Re: Certificate of Appropriateness for 909-915 Jenifer Street

PLANNING DIVISION STAFF REPORT

Project Name & Address: 909-915 Jenifer Street

Application Type(s): Certificate of Appropriateness for an addition in the Third Lake Ridge Historic District

SITE PLAN PROPOSED

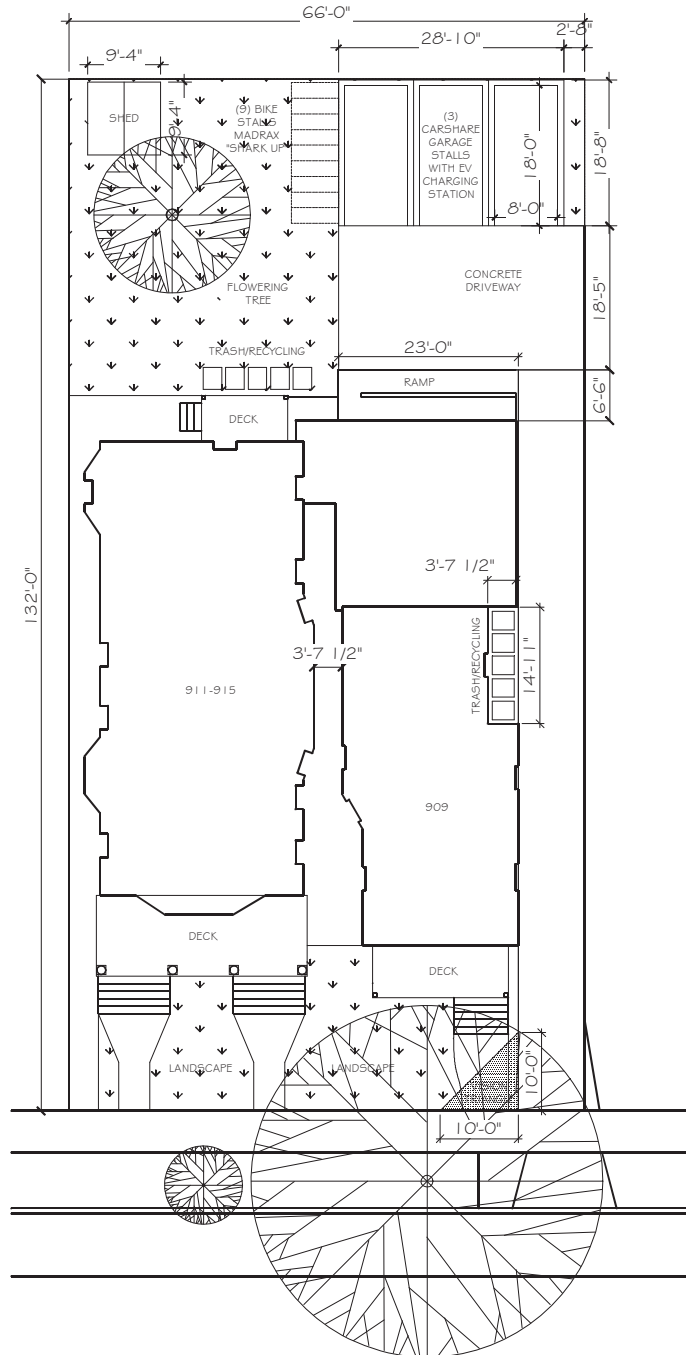
The basement-level connector will be minimally visible from the public right-of-way as the two buildings 3'-7" apart at their midpoints and 4' apart at the point of the proposed connection on the rear of the buildings. The connection is noted on the plans as a plinth. It is unclear how the plinth will appear above grade.

- a. The exterior addition is of a compatible scale and design as other rear additions on historic resources within 200 feet.
- b. The existing parking lot on the rear of the property will be reconfigured to accommodate the new addition while still providing parking spaces for residents. It will be minimally visible from the street and as unobtrusive as possible. The plinth, while a structure that will connect the two existing historic houses together at the basement level, operates as more of a landscape feature. It's location between the two structures, that are approximately 3-feet apart, and the proposed landscaping will make this new landscape feature as unobtrusive as possible.

1. Door and window specifications
2. ADA ramp and railing design
3. Roof shingle specifications
4. Above-grade cladding or landscaping treatment of the plinth connector

ROOF PLAN PROPOSED

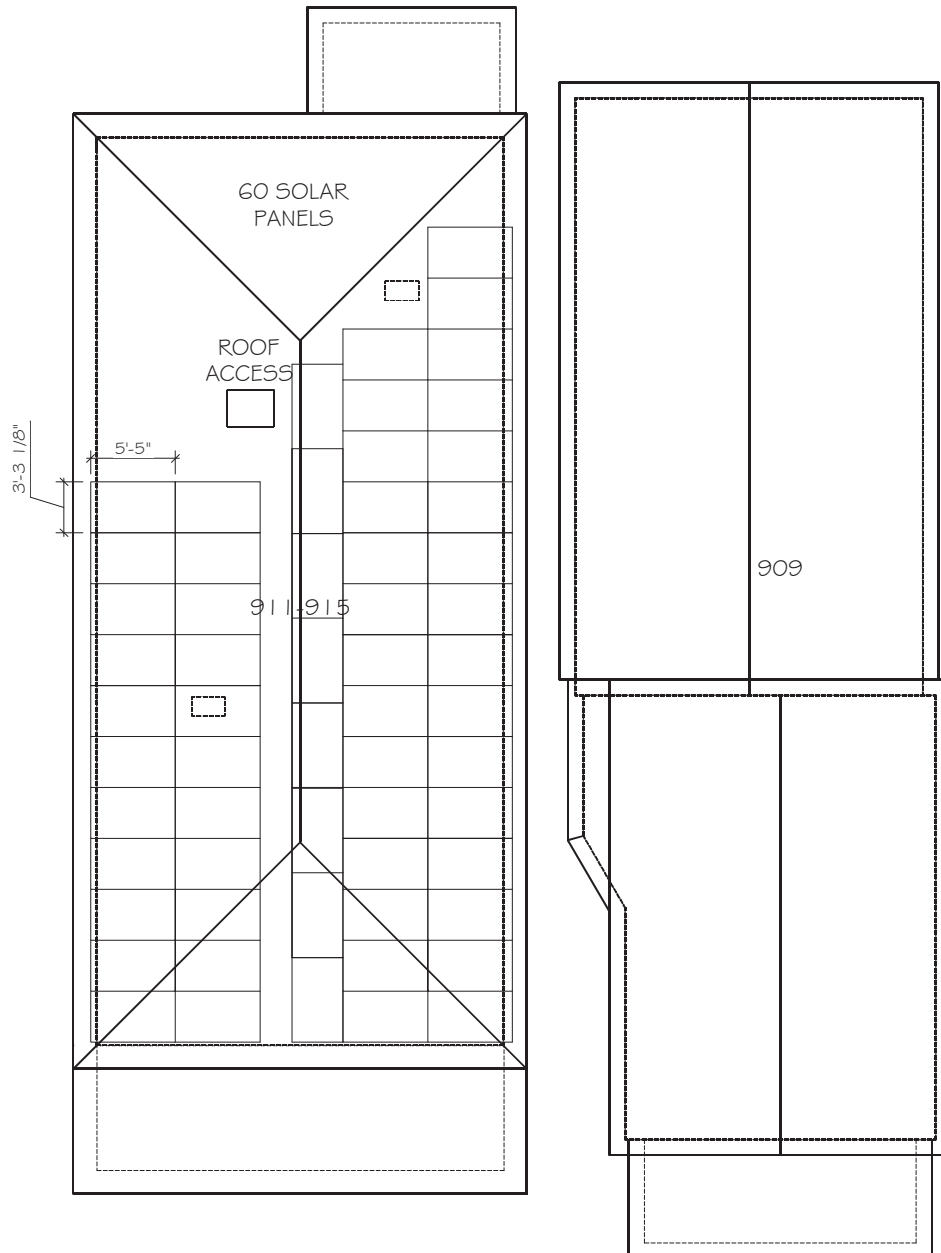
1. **Solar Panels:** The current proposal is not approved. Solar panels must be located on the roof so that they are only minimally visible from the public right of way. The roof plan and solar panel locations provided do not appear to take into account the geometry of the hipped roof and do not appear accurate and you have not included sufficient information for review. To ensure that panels are not overly visible from the public right of way, the panel array must be shifted to the back of the property and no panels should be mounted forward of the peak of the hip on the northern end of the roof. In addition, you have not provided enough information for review of the panels, specifically you must submit details of how they will be mounted to the roof, height of any mounting system, angle of panels, and a section through the panels and roof slope showing the slope and height of the panels. To ensure compliance with the Standards you must submit the documentation requested above for review and approval prior to installing any panels. A mock-up may be necessary to ensure compliance with the Standards.

SE ELEVATION PROPOSED

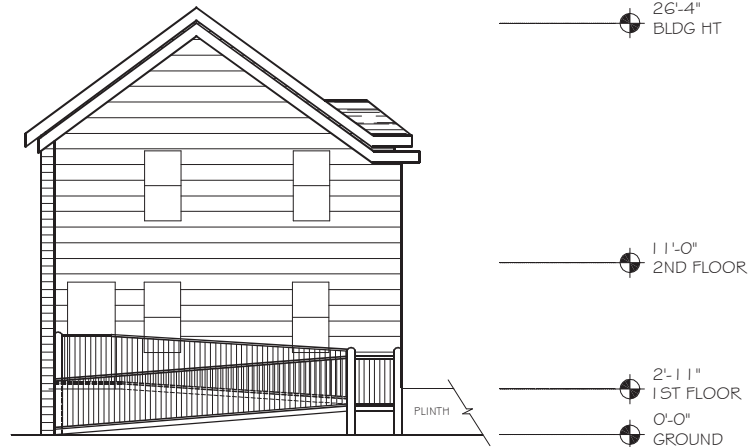
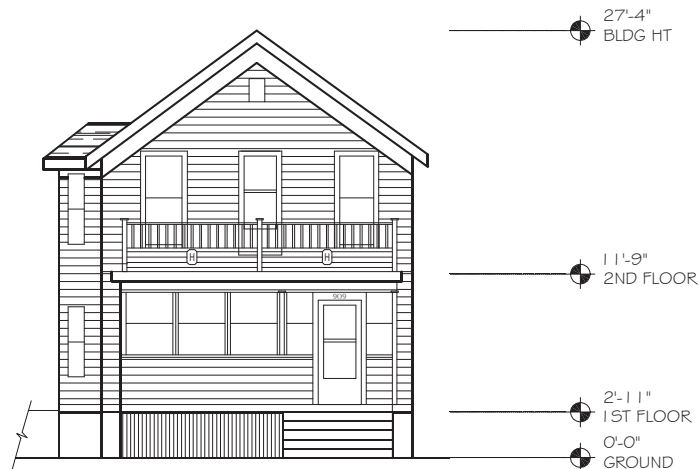
There is a discrepancy between the submitted plans, which show a 12" reveal on the clapboards, and the plans approved by the NPS, which show a 6" reveal. The 6" reveal would differentiate the historic from the new construction but be comparable to the historic resources. The 12" reveal would contrast with the historic resources.

- d. The addition is visually separated from the historic by a slightly wider clapboard and a separation in the roofline between the historic and the new addition.

- a. The materials for the exterior cladding will be a 6-inch clapboard, which will be compatible with the historic 4" reveal clapboard on the historic structure.

- a. The addition will have a gable roof, same as the historic structure, but will have a slightly lower pitch. The new roof will be visually compatible.
